TO: Jennifer Fitch, PE Project Manager Vermont Agency of Transportation	DATE	PROJECT NO.
	10/2/2014	Brookfield BRF FLBR (2)

COPIES	NUMBER	DESCRIPTION	CODE
1		FRP Fabrication NCR 12 - Rafts 1 & 2 - Misaligned Bolt Hole	H

Brookfield BRFLBR (2)
Misaligned bolt hole – Raft #2

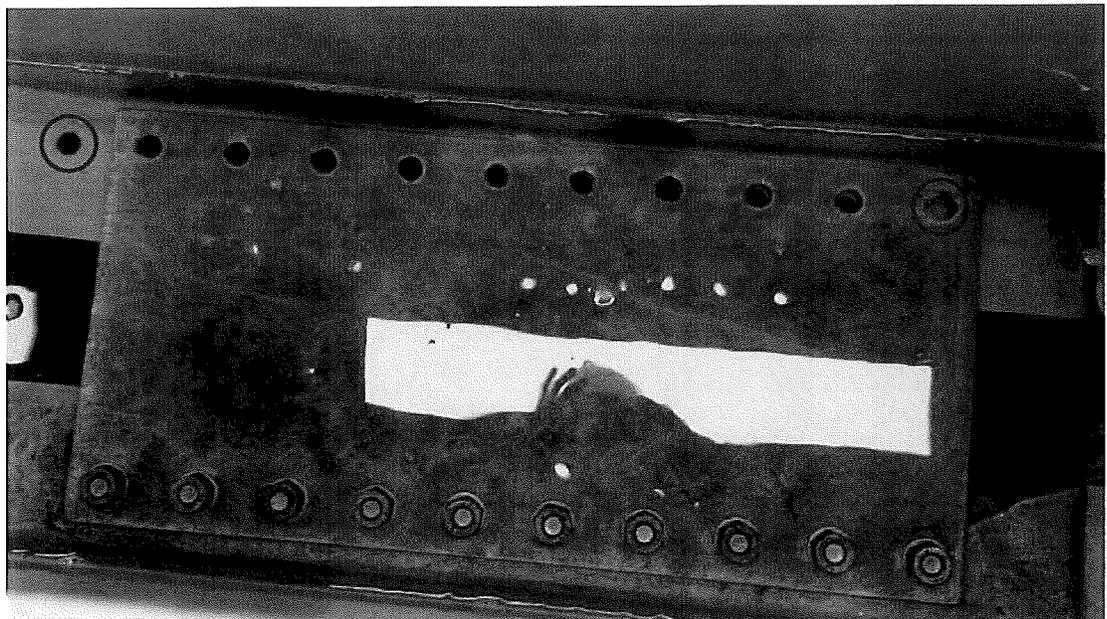
During joining operations between Rafts 1 and 2, Miller identified misaligned bolt holes along one edge of the outer bottom flange (16.5" x 34.5") splice plate connection.

While drilling the first set of 1/8 in. pilot holes in the large splice plate between Rafts 1 and 2, two or three 1/8 in. drill bits were broken and stuck in the corners of the template due to an excessively tight fit inside the bushing. At that point, the technician switched to 7/64 in. drill bits to avoid the issue. Also, given the difficulty associated with reaching the

bottom flange holes, only the corner holes in the templates were initially drilled, the templates repositioned once the rafts were separated, and remaining pilot holes drilled. Looking back, it appears that the template was shifted over one hole in order to make use of it until the stuck drill bit(s) could be removed. Unfortunately, the template must have been shifted in the wrong direction on Raft 2 once it had been separated from Raft 1.

To correct the discrepancy, Kenway plans to drill the missing bolt hole in place using an extension if necessary to clear the water. The steel plate will be used as a template to align the bit. If the Agency is concerned about drill spoils, a wet/dry vacuum could be used while drilling in an attempt to capture as much debris as possible. An epoxy resin that cures underwater could be used to seal the hole if desired. The extra bolt hole will simply remain open.

Once the 7/64 in. pilot bits were used and the stuck bits removed from the template, there have been no other issues piloting bolt holes. All pilot holes (not just the corners) are being drilled at the same time in every plate location at the initial placement of the template. Along with QA inspection procedures, this will ensure the misaligned bolt hole issue will not be repeated.
